Access Compliance Report

Public Rights-of-Way

(Curb Ramps)

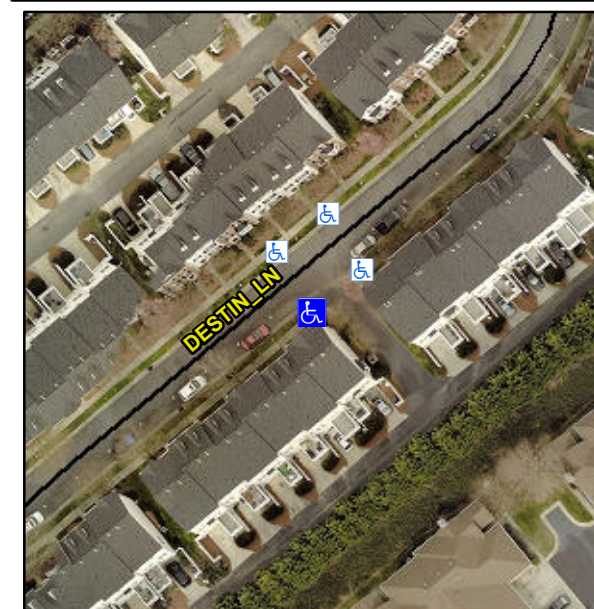
Not Found, R304.5.1, R304.5.3

Compliance	Description	Data	Compliance	Description	Data
N/A	Ramp Length (in)	53.0	Yes	BlendTrans Slope (%)	3.7
No	Ramp Width (in)	43.0	No	BlendTrans XSlope (%)	6.2
N/A	Flare Type LT	N/A	N/A	Flare Type RT	N/A
N/A	Flare Slope LT (%)	N/A	N/A	Flare Slope RT (%)	N/A
N/A	Flare Traversable LT?	N/A	N/A	Flare Traversable RT?	N/A
N/A	Landing Length (in)	N/A	N/A	DWS Provided?	N/A
N/A	Landing Width (in)	N/A	N/A	DWS Contrast?	N/A
N/A	Landing Slope (%)	N/A	N/A	DWS Length (in)	N/A
N/A	Landing X Slope (%)	N/A	N/A	DWS Full Width?	N/A
N/A	Landing Curb? (Y/N)	N/A	N/A	DWS Offset (in)	N/A
N/A	Shared Landing?	N/A			
N/A	Gutter Ponding?	N/A	N/A	Gutter Slope (%)	N/A
N/A	Gutter Lip Ht (in)	N/A	N/A	Gutter X Slope (%)	N/A
N/A	Painted X Walk1?	No	N/A	Painted X Walk2?	No
	X Walk 1 Direction	To NE		X Walk 2 Direction	To NW
	X Walk 1 Width (in)	N/A		X Walk 2 Width (in)	N/A
	X Walk 1 Slope (%)	1.4		X Walk 2 Slope (%)	0.1
	X Walk 1 X Slope (%)	1.0		X Walk 2 X Slope (%)	1.2

N/A	Ramp inside XWalk1?	N/A	N/A	Ramp inside XWalk2?	N/A
	Road Slope (%)	2.4		Clear Space?	N/A
	Road X Slope (%)	1.2	N/A	Clear Space to XWalk (in)	N/A
N/A	Any Obstructions?	N/A	N/A	Storm Grate/Utility Hazard?	N/A
	Obstruction Type			Storm Grate/Utility Type	
		N/A			N/A
			Yes	Surface Condition? (G/P)	Good
			No	Curb Slope (%)	6.0

Remove & Replace Curb Ramp With Two New Directional Ramps or Equivalent.
